UNITED STATES PATENT AND TRADEMARK OFFICE

| APPLICATION NO. | FILING DATE | FIRST NAMED INVENTOR | ATTORNEY DOCKET NO. | CONFIRMATION NO. |
|-----------------|-------------|----------------------|---------------------|------------------|
| 10/534,848 | 05/13/2005 | Arnaud Metayer | 825-02-630 | 8918 |

| Office Action Summary | Application No. 10/534,848 | Applicant(s) METAYER ET AL. | |

DETAILED ACTION

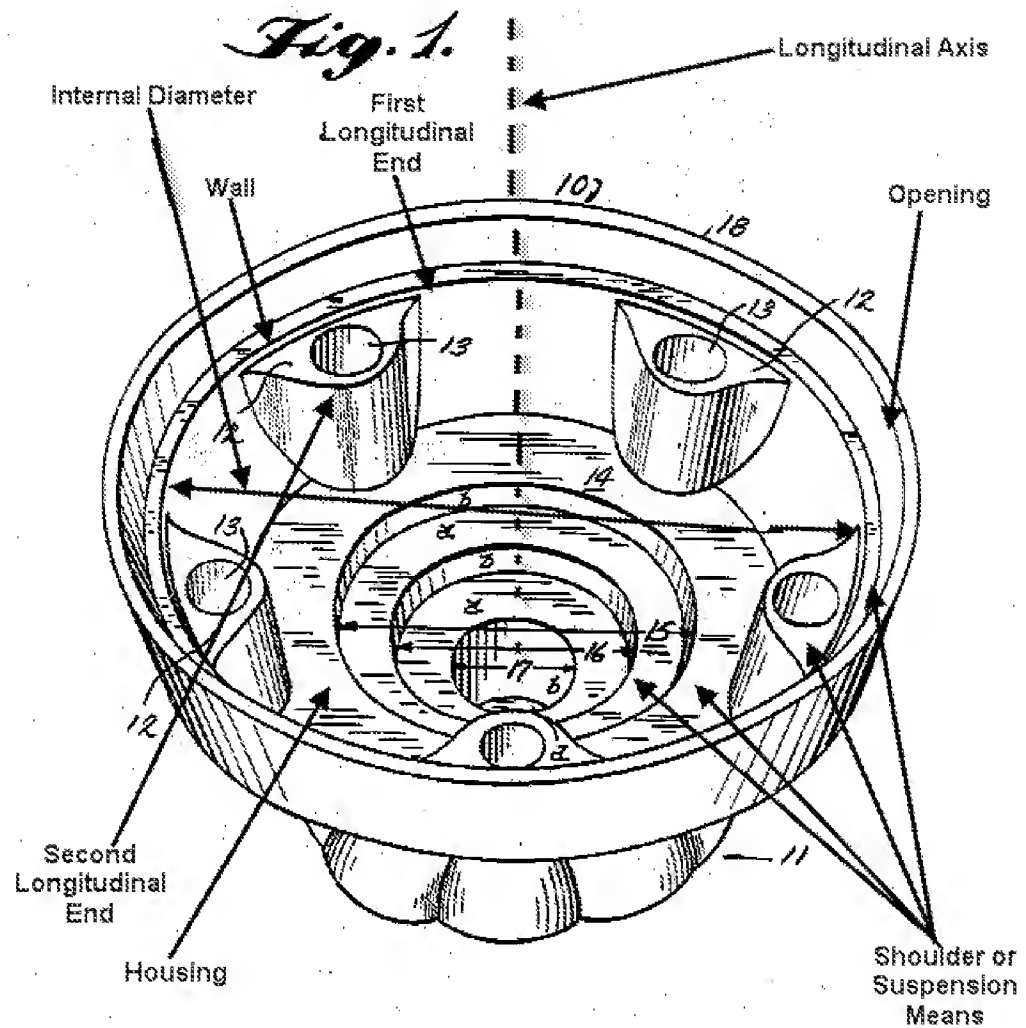
a wall connecting the first longitudinal end to a second longitudinal end;
at least one suspension means or shoulder made in the wall so that a non-zero distance separates the shoulder and a first or second face of the appropriately sized brake disc, facing towards the second longitudinal end of the housing (See marked up figure 1).

Regarding claim 2, Fenton further discloses the suspension means or the shoulder (of width such that the shoulder collaborates with a radially external end of a first or second face of an appropriately sized brake disc) connecting a larger-diameter first cylindrical portion of the longitudinal axis (of a diameter greater than the diameter of the appropriately sized brake disc) and a smaller-diameter second portion of the longitudinal axis (see marked up figure 1).

Regarding claim 3, Fenton further discloses the shoulder being made of at least two parts arranged in one and the same plane and formed by angular sectors distributed, advantageously uniformly, over the periphery of the housing (see marked up figure 1).

Regarding claim 4, Fenton further discloses the housing having several shoulders arranged in parallel planes so that the storage element is capable of taking brake discs of different diameters (see marked up figure 1).

Regarding claim 5, Fenton further discloses each shoulder connecting a larger-diameter part to a smaller-diameter part, and the smaller-diameter part forming the next larger-diameter part, and in that each larger-diameter part has an axial dimension along the longitudinal axis capable of being at least equal to half the distance separating first and second faces of an appropriately sized brake disc (see marked up figure 1).

Regarding claim 6, Fenton further discloses the smaller-diameter portion of the suspension means along the longitudinal axis from the first longitudinal end of the housing towards the second longitudinal end forms the larger-diameter portion of a next suspension means (see marked up figure 1).
